Work Order ID 59075

Item Name: Floor Protector, Aft LH

DART AEROSPACE LTD		Work Order:	59075
Description: Floor Protector, Aft LH		Part Number:	D3281-3
Inspection Dwg: D3281	Rev: DE DL		Page 1 of 1

DRAWING NO. D3281	TITLE FLOOR PROTECTOR	REV. E	DART AEROSPACE LTD ENGINEERING ORDER	D.E.O. NO. D3281-E-1	SHEET NO. SHEET 1 OF 1	SCALE NTS
DRAWN <i>qp</i>	CHECKED <i>kl</i>	MFG. APPR. <i>kl</i>	APPROVED <i>kl</i>	DE APPR. <i>kl</i>		
DATE 10.02.24	DATE 10.02.25	DATE 10/02/25	DATE 10.02.25	DATE 10.02.25

D3281-1L08 FLOOR PROTECTOR (SHOWN)
D3281-2L08 FLOOR PRETECTOR (OPPOSITE)
LOCATION OF ENGRAVING

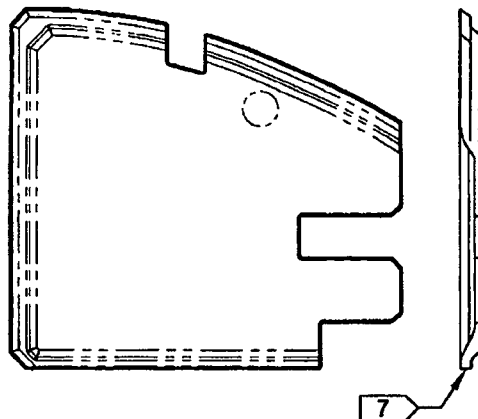
ADD "D3281-xL08" MATERIAL OPTION. EXISTING PARTS TO BE IDENTIFIED AS "D3281-xL02"

D3281-xL08 PARTS ARE EQUIVALENT TO THE RESPECTIVE "-x" PARTS EXCEPT AS DETAIL BELOW. THE MATERIAL, IDENTIFICATION, AND WEIGHT NOTES ARE AMENDED AS FOLLOWS:

- 2) MATERIAL: -xL02 = LEXAN F6006, BLACK No. 701, 0.093" THICK (MLEXS.093-F6006-02)
-xL08 = LEXAN 90318 (PROTECT-A-GLAZE), 0.118 THICK, 112-CLEAR (MLEXS.118-90318-08)

- 7) IDENTIFICATION: IDENTIFY WITH DART P/N "D3281-xLxx" AND B/N "Bxxxxx" ON SMOOTH SIDE OF PART USING VIBRATING STYLUS.
FOR -xL08 PARTS, LOCATE ENGRAVING ALONG PERIMETER OF PART AS SHOWN.

- 8) WEIGHT: D3281-1L02/-2L02 = 0.95 lb D3281-1L08/-2L08 = 1.13 lb
D3281-1L02/-2L02 = 0.87 lb D3281-3L08/-4L08 = 1.05 lb
